96-18-22 ROBINSON HELICOPTER COMPANY : Priority Letter issued August 29, 1996.  
Docket No. 96-SW-25-AD.

Applicability: Model R44 helicopters, with main rotor gearbox (gearbox), part number (P/N) C006-1, Revisions A through P, installed, certificated in any category.

**FIGURE 1**

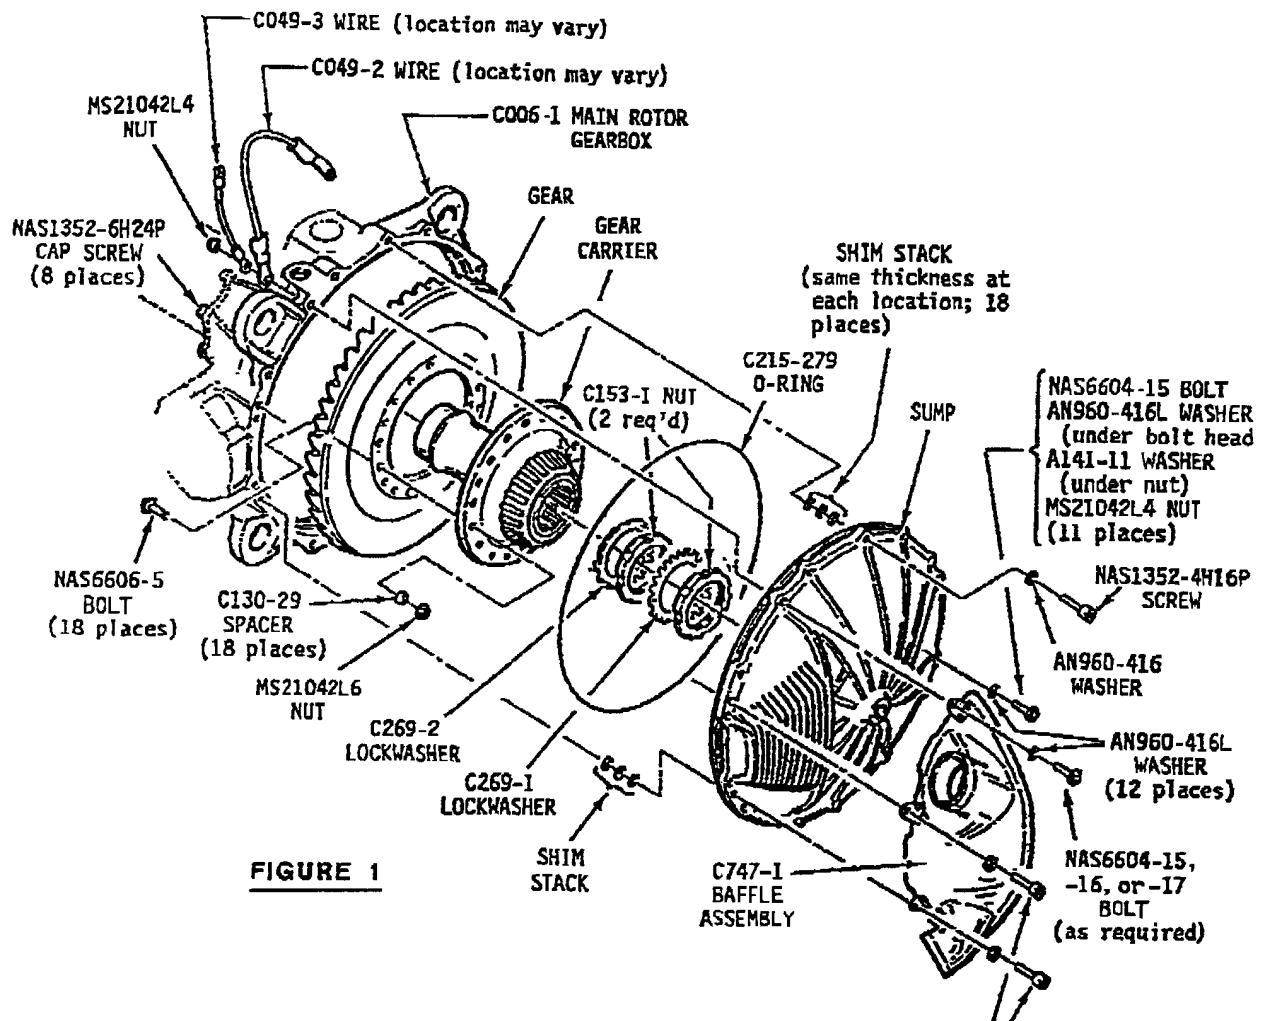
(b) Lay the gearbox on its side with input yoke up. Loosen the eight cap screws attaching the mast tube to the gearbox, but do not remove the screws. Remove the twelve bolts and six cap screws holding the sump and baffle in place (Figure 1). Note the location of ground wires.

**FIGURE 2**

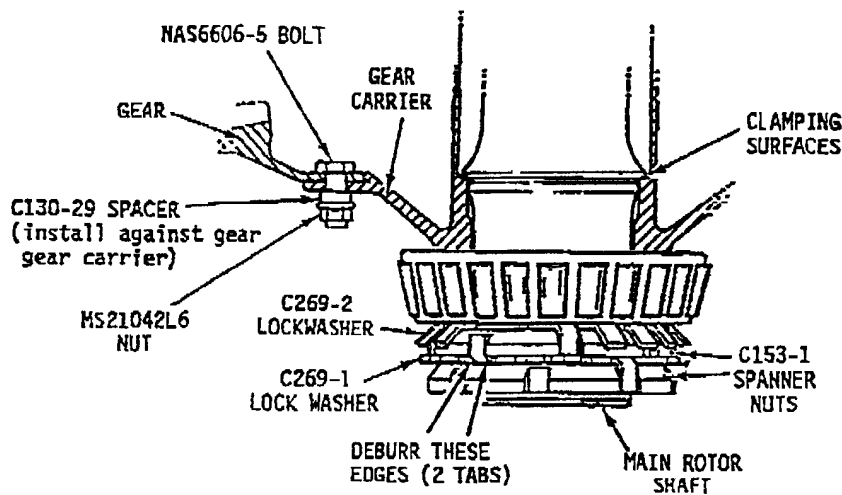
(h) Align the gear to the gear carrier and install NAS6606-5 bolts, spacers, P/N C130-29, and MS21042L6 nuts in 18 places (Figure 2). Keep the mating surfaces and hardware dry, clean, and free of oil. Torque the nuts to 40 ft.-lb. (includes self-locking torque) using the torquing sequence shown on Figure 3.

(l) Before installing the unused lockwasher, P/N C269-1, note that the edges are sharp on one side and rounded on the other. De-burr the sharp edges on two opposite tabs (Figure 2). This will reduce the chance of cracking when these tabs are bent. Install the lockwasher with the de-burred edges toward the first nut.
